AGENDA FOR THE REGULAR MEETING OF THE PLANNING COMMISSION

Re: Darlington Pointe II
Final Minor Subdivision (Lot Line Change)
Lots 4 and 5 of Darlington Pointe II Subdivision
Tax Folio Nos. 27-00-01895-03 & 27-00-01895-04
Middletown Township, Delaware County

This office reviewed the subject final minor subdivision (lot line change) plan, dated June 11, 2020, titled "Final Minor Lot Line Revision Lots 4 & 5 Darlington Pointe II", prepared by G.D. Houtman & Son, Inc., received by the Township on July 23, 2020.

Re: Darlington Pointe II
Final Minor Subdivision Plan (Lot Line Change)
Lots #4 & 5

Project information block including date (June 11, 2020), scale (1"=40'), title (MINOR LOT LINE REVISION LOTS 4 & 5), client (G.D. HOUTMAN & SON, INC.), and sheet number (Sheet 1 of 1).

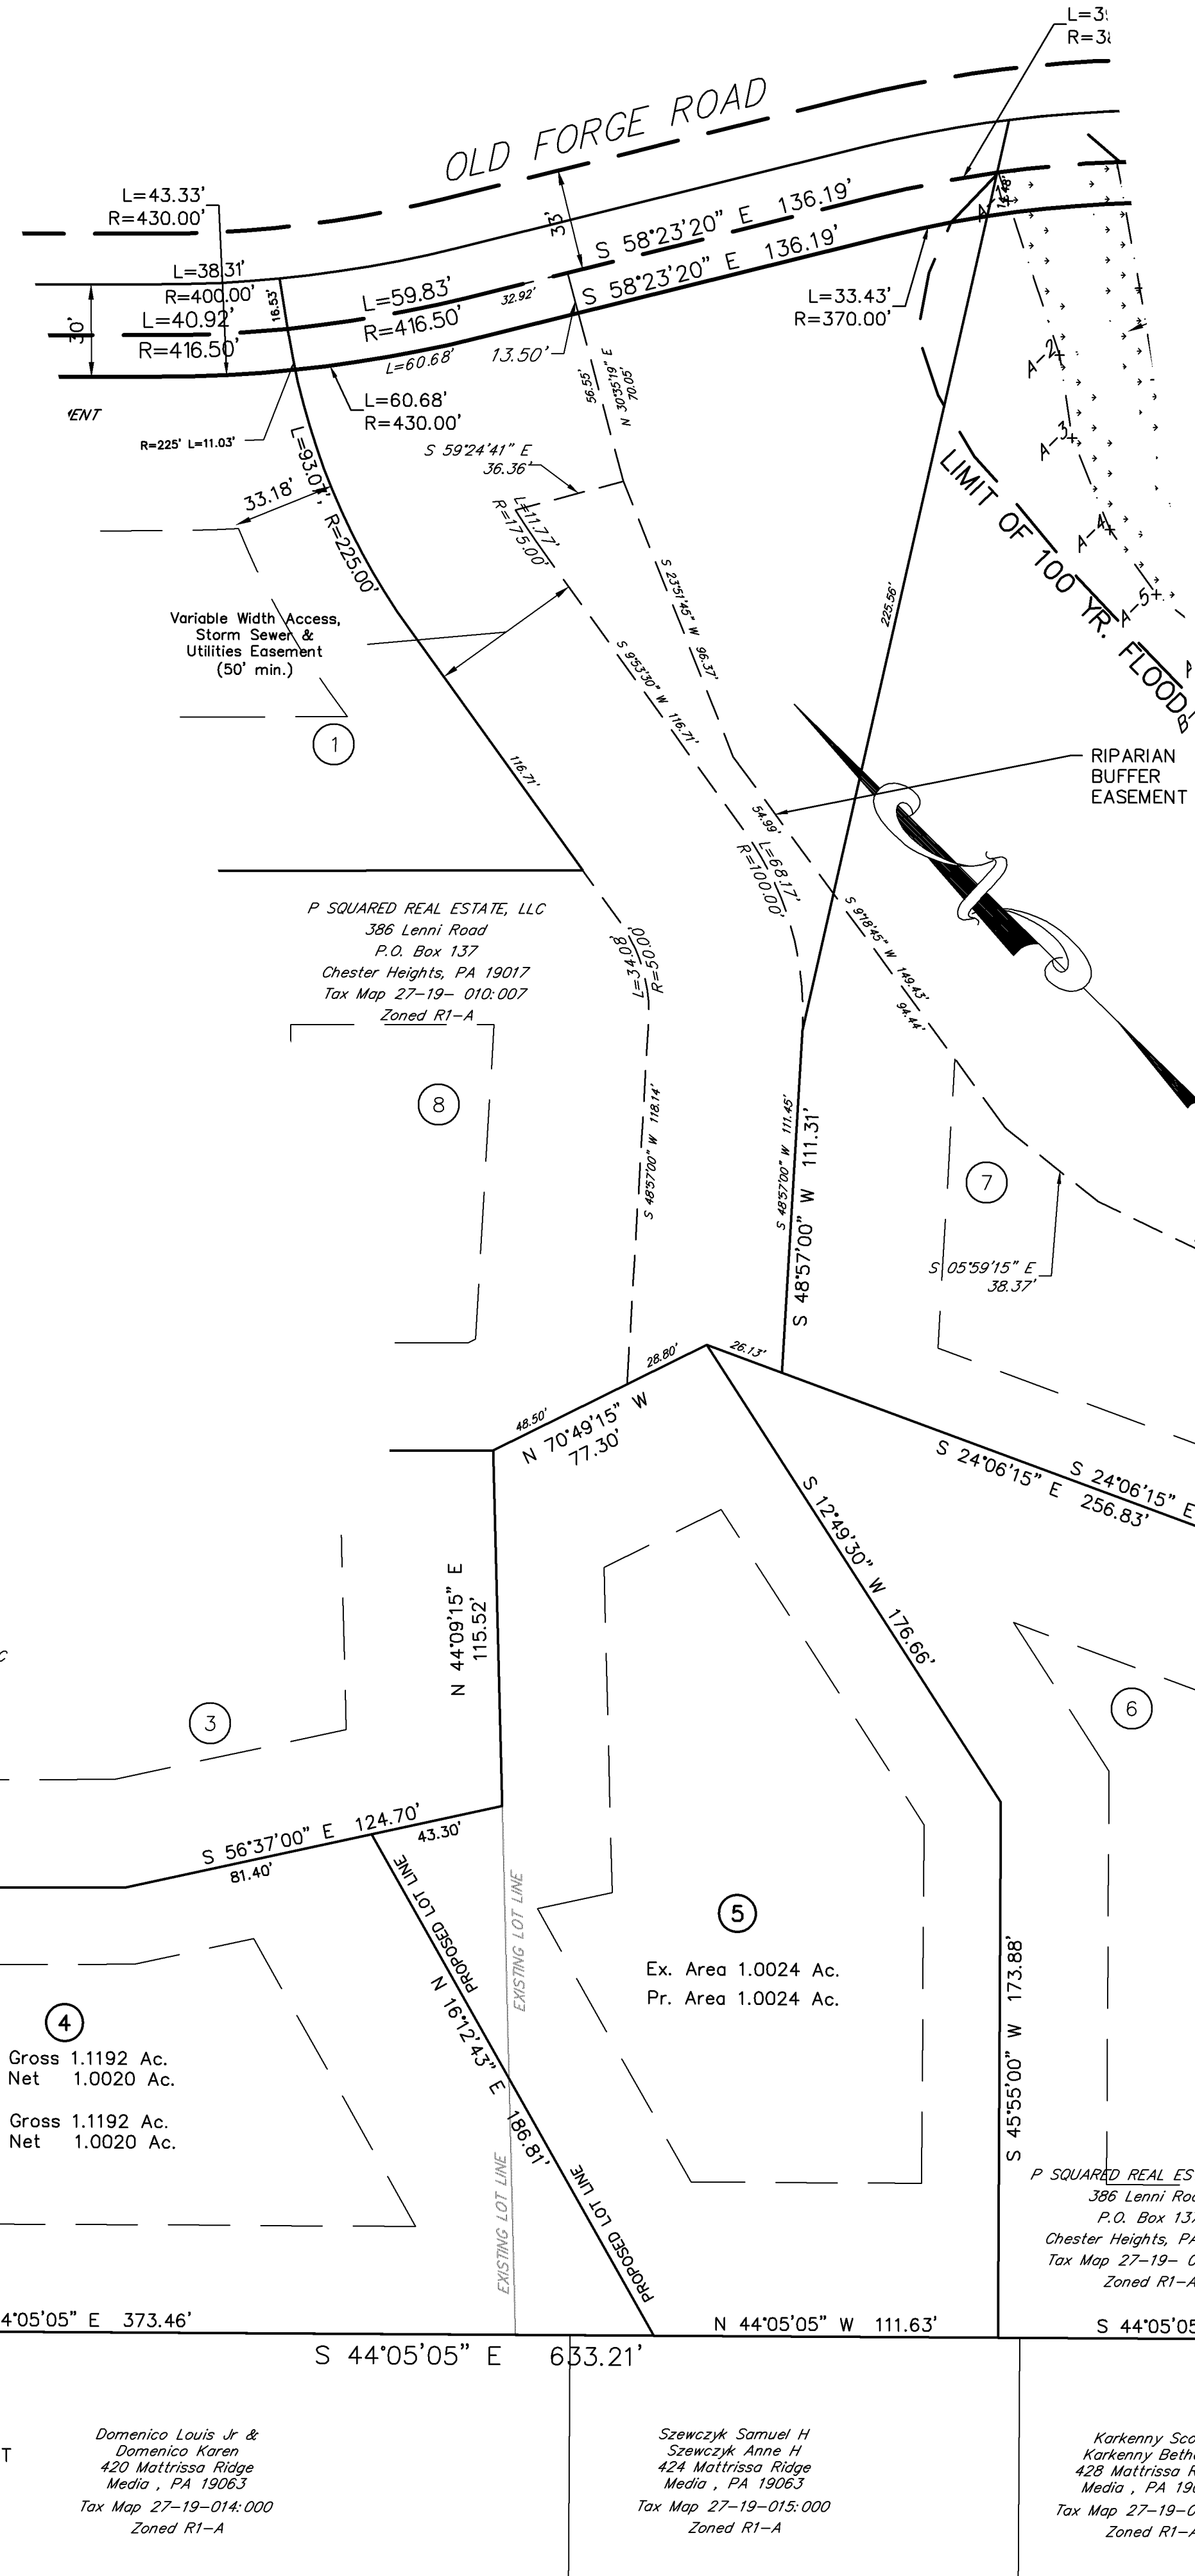
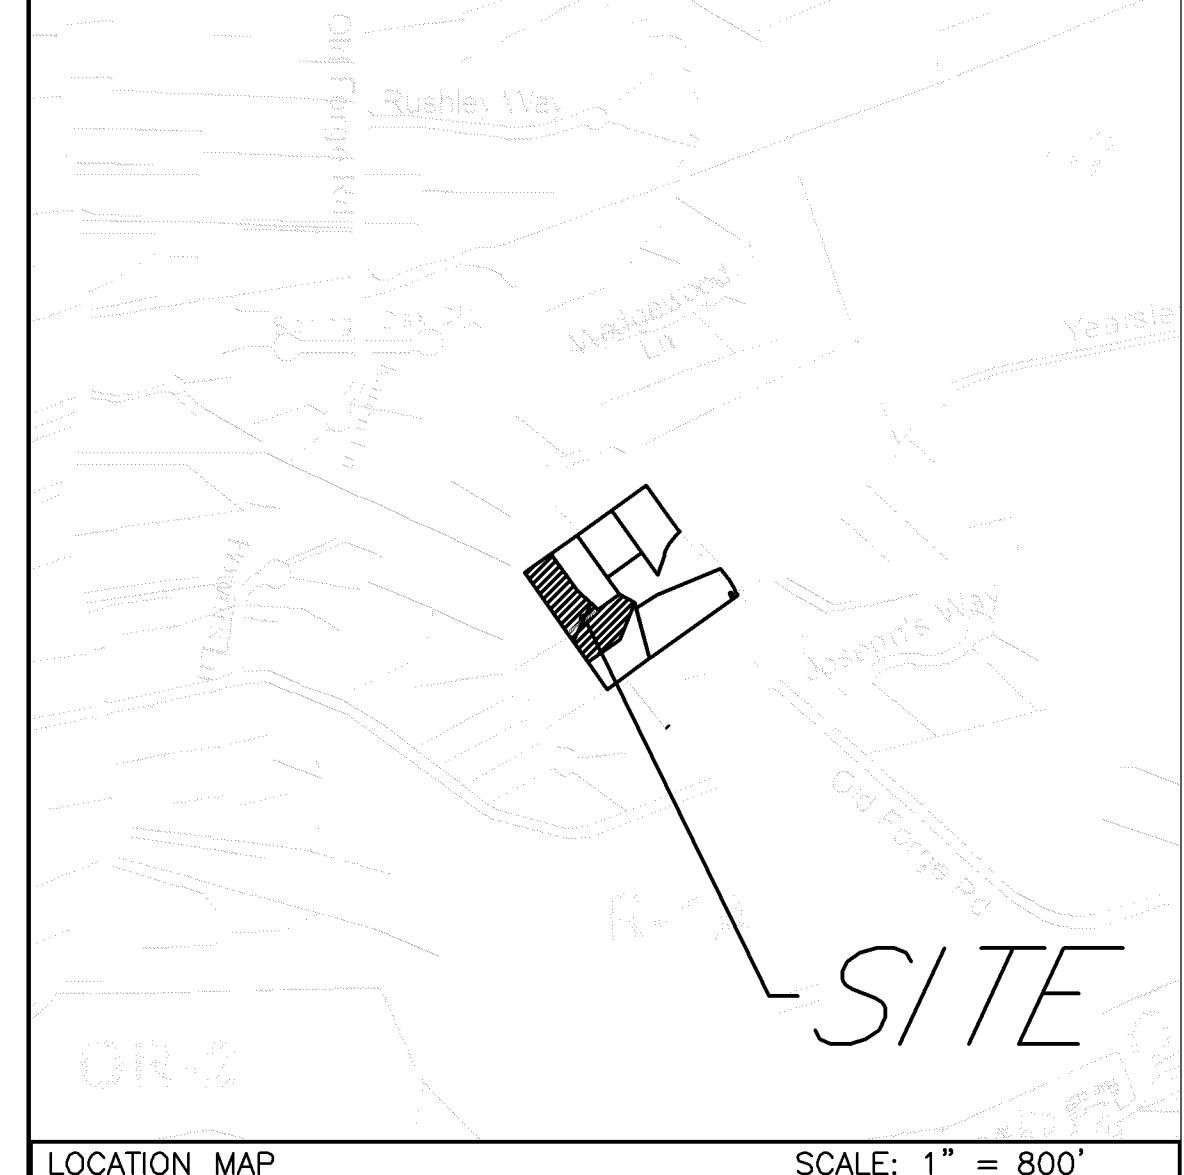
2. The plan must be reviewed by the Delaware County Planning Department (§210-9.B).
3. Plan does not identify existing corners (of the boundary to be revised) found or clarify if any corner markers are to be set. Concrete monuments and/or lot corner pins are also required to be set at locations specifically summarized in the ordinance. Outboundary corner markers must be installed and certified prior to recordation of the plan (§210-20.A(2), §210-20.A(3), 210-20.B(14) & §210-27).

5. The plan should reference the recording information for the Darlington Pointe II Major Subdivision.
6. The plan must be revised (to the extent applicable) to incorporate plan notations required pursuant to "Middletown Township Standards and Specifications". A copy of these notations will be forwarded to the design engineer under separate correspondence.
7. Upon resubmission the applicant must include a response letter addressing every comment made within this review letter, the design engineer must also submit electronic copy of each plan sheet and reports in "pdf" format, to both the Township and Township Engineer.

This Plan is a simple Lot Line revision therefore we request that the Lot corners be set prior to issuance of a Certificate of Occupancy (CO) for each of the Lots. If the corners are set prior to the start of construction, they would likely be disturbed or removed during the grading of the Lots.

The requested information will be added to the Plan for the next submission.

The requested information will be added to the Plan for the next submission.
